UNITED STATES
DEPARTMENT OF THE INTERIOR
BUREAU OF LAND MANAGEMENTFORM APPROVED
OMB No. 1004-0137
Expires: January 31, 2018**SUNDRY NOTICES AND REPORTS ON WELLS**
Do not use this form for proposals to drill or to re-enter an abandoned well. Use Form 3160-3 (APD) for such proposals.5. Lease Serial No. NMNM 0426782 ✓
6. If Indian, Allottee or Tribe Name

8. Well Name and No. MARY FEDERAL #5 ✓

9. API Well No. 30-015-25378 ✓

Recompletion procedure:

Well: MARY FEDERAL-5

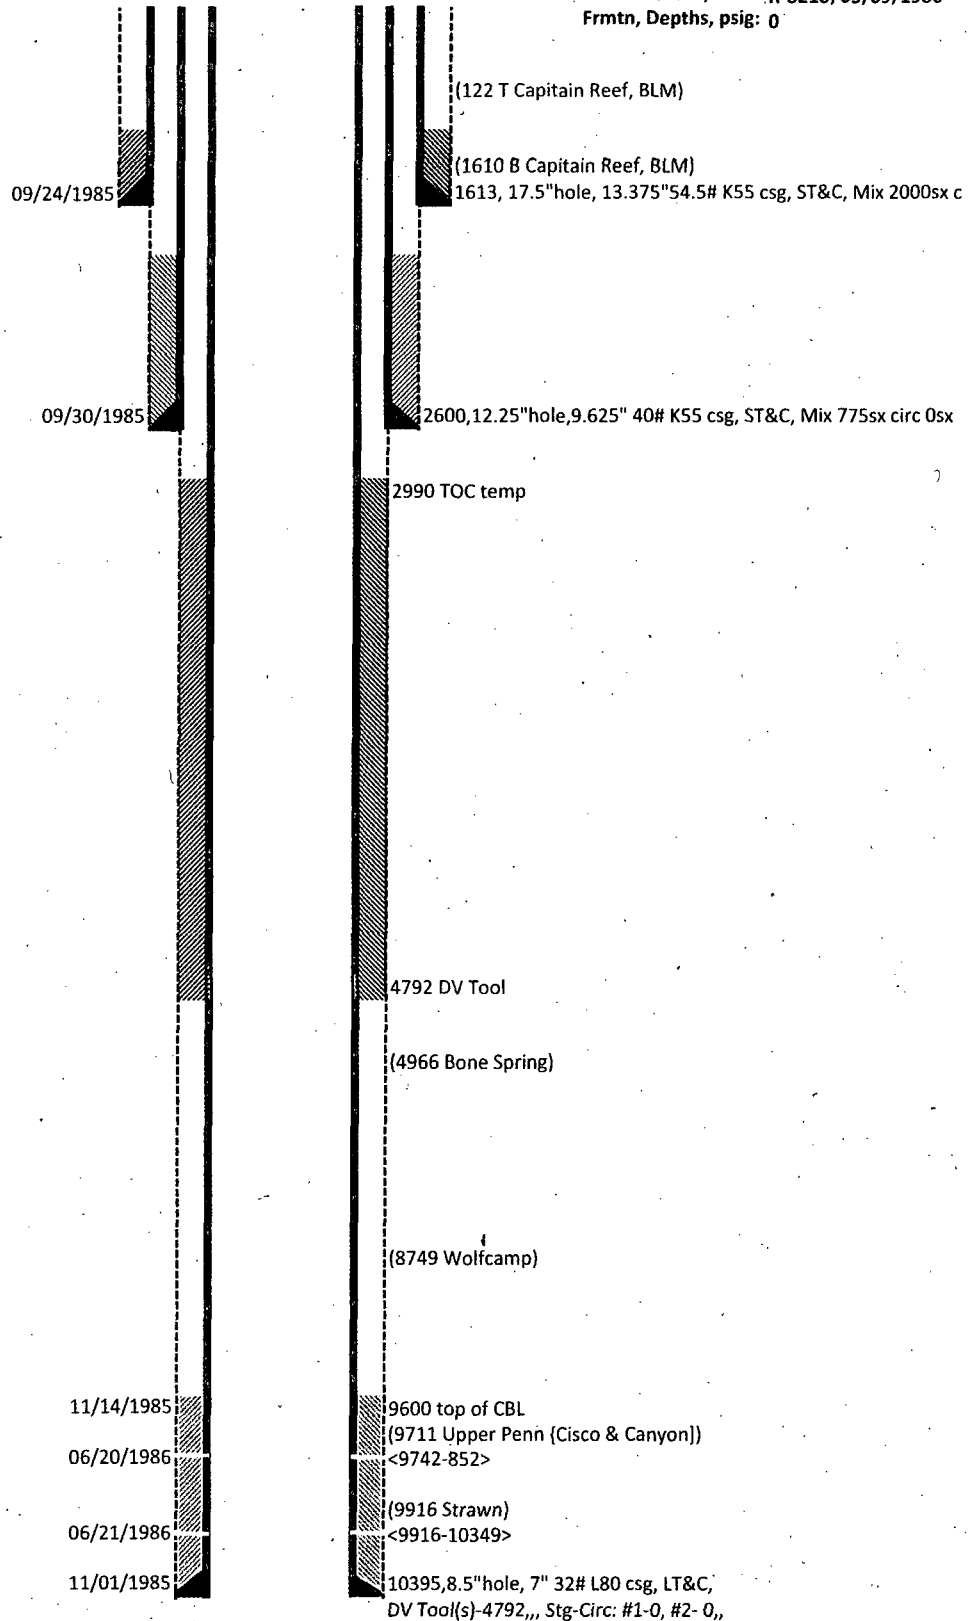
*Returned, lack info
See attachments*

Production Cement to cover casing 50 feet above Capitan Reef top. High Cave Karst: two casing strings, both to circulate cement to surface. Carlsbad Controlled Water Basin.

Proposed volume of tail cement below should circulate to surface.

4 1/2 casing inside the 7 "A" Buoyant				Design Factors		PRODUCTION			
Segment	#/ft	Grade	Coupling	Joint	Collapse	Burst	Length	Weight	
"A"	11.60	P 110	U F Joint	1.35	1.17	1.76	13,000	150,800	
w/8.4#/g mud, 30min Sfc Csg Test psig: 1,810						Totals:	13,000	150,800	
A Segment Design Factors would be:				1.84	1.24	if it were a vertical wellbore.			
The cement volume(s) proposed may achieve a top				0	feet from surface.				
Hole Size	Annular Volume	Proposed Sx Cmt	CuFt Cmt Proposed	Min Cu Ft	Excess % Cmt	Drilling Mud Wt	Calc MASP	Req'd BOPE	Min Dist Hole-Cplg
5 1/2	0.0545			1103		9.00			0.49
Proposed Recompletion: Set 7" whipstock at 9050 and drill a lateral. The NOI is lacking a wellpath plan, a spec sheet for the 4 1/2" csg w/ specific coupling discription, proposed bottom hole location, cementing discription, and a NMOCD C-102.
